Sandown Quarry Landfill Restoration  
Stubbers Green Road, Aldridge, Walsall  
Surface Water Management Plan  
Addendum

Report Ref. 07200/SWMP/R02

This addendum is to accompany the Surface Water Management Plan submitted with the planning application and is to provide additional information in response to comments.

Client	Byrne Looby
Project	Sandown Quarry Restoration WS9 BBL
Drawing title	Exceedance Flow Routes
Scales @A1	1:1000
Date	July 2023
Status:	Information
Drg No.:	07200 - 101
Rev.:	01

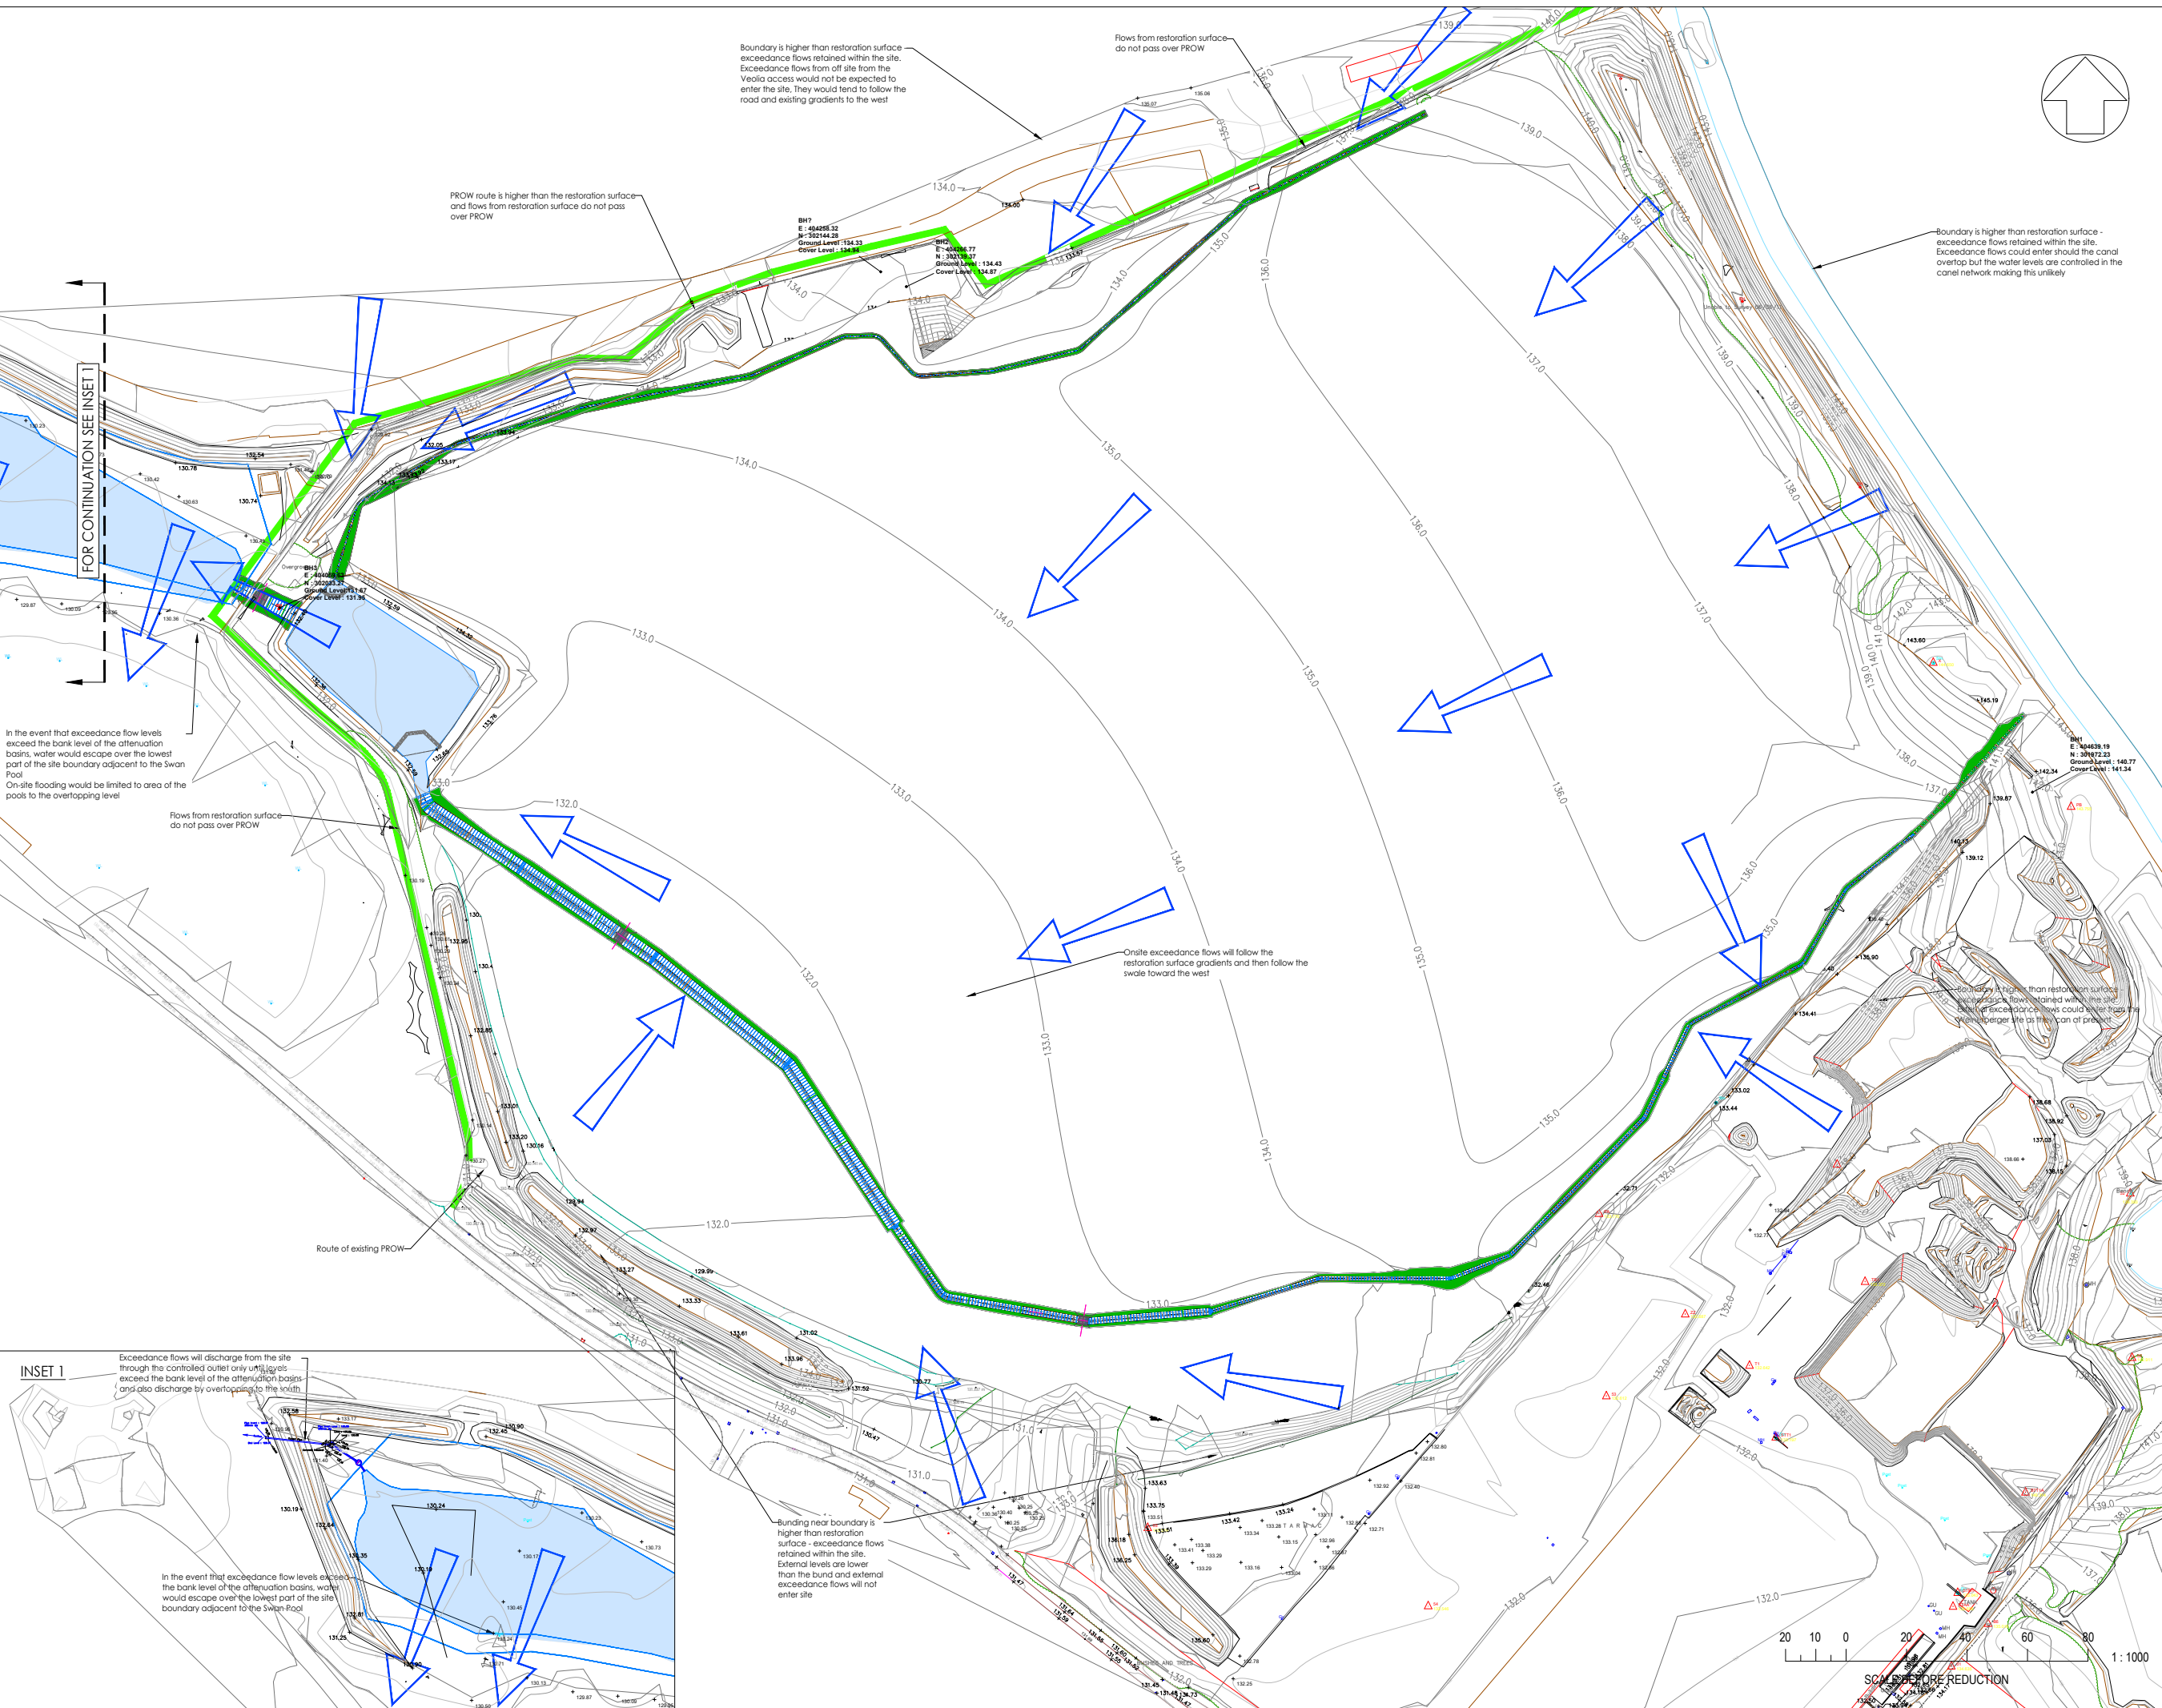
Rev	Description	Date	Dm	Cnd
01	OUTFALL SURVEY ADDED & OUTFALL	24.08.23	JC	TG
	DETAIL UPDATED, MINOR DRAINAGE UPDATES		TG	
00	REPORT ADDENDUM ISSUE	28.07.23	JC	TG
